Drawing Amendments

Substance of Interview

FIG. 2B

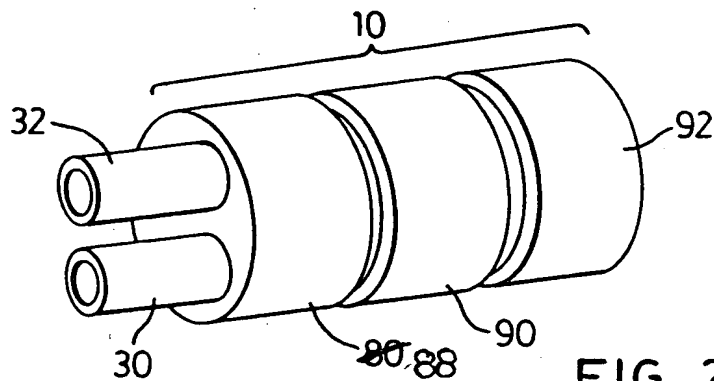
In Figure 2B, Applicant has amended reference numeral "80" to read "88". The specific changes are marked in red on the enclosed marked-up copy of the amended drawings.

In the Examiner's June 21, 2005 report, the Examiner objected to the drawings because in Figure 2B (filed on 1/3/05), "80" should be changed to "88". Figure 2B has been amended accordingly.
